KANSAS CITY AREA TRANSPORTATION AUTHORITY  
1350 E. 17<sup>TH</sup> STREET  
KANSAS CITY, MISSOURI 64108

**ADDENDUM 1**  
**INVITATION FOR BID (IFB) #F19-5030-20C UG VANS**

Issue Date: November 15, 2019

Diagram: Top View of TRANSIT 350 EL DRQ with Smart Floor Bus Door, Rear Lift and 10 Rear Seats

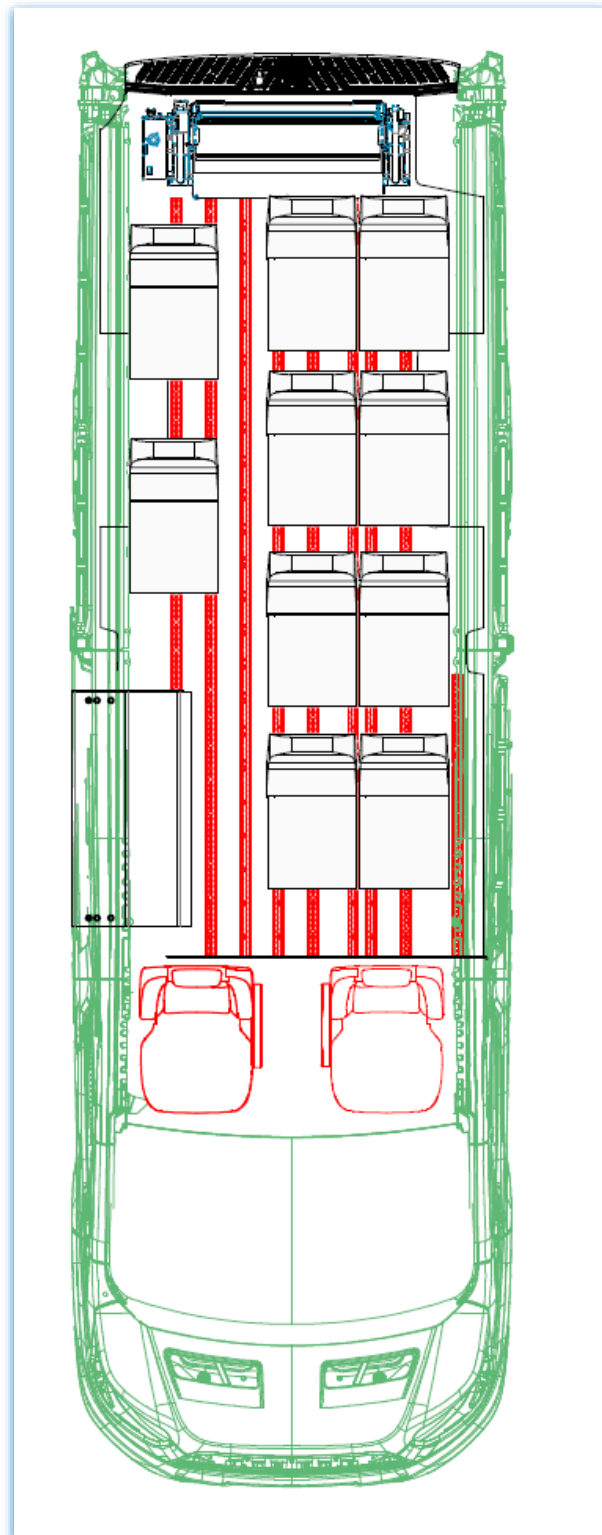
**Question 3:** One requestor has asked for clarification on the paratransit package, including a request for some type of floor plan and/or seating arrangement.

- A) Which brand of floor rail system is accepted, and are Q'Straint L-Tracks included?
- B) If Q'Straint is approved, the Slide/Click system cannot be used. Please clarify.
- C) How many wheelchair positions are being requested?
- D) Can the KCATA provide a floor plan?

**Answer:** The KCATA has been provided a computer-generated floorplan. This depicts the top view of a Ford Transit 350 EL DRW with Smart Floor, including a bus door, rear lift, and 8 removeable (required) to 10 (optional) rear seats (see the diagram for the 10-person layout), including a configuration for four wheelchair positions. The floorplan is provided on the end of Addendum under **Supplement 1-1.**

- A) Which brand of floor rail system is accepted? SmartFloor brand was suggested, but approved equals are potentially approved based on the form, fit, and functionality.
- B) If Q'Straint is approved, the Slide/Click system cannot be used. Please clarify. This is potentially approved with the Q'Straint system.
- C) How many wheel chair positions are being requested? Four wheelchair positions need to be available.
- D) Can the KCATA provide a floor plan? See the attached at the end of Addendum 1.
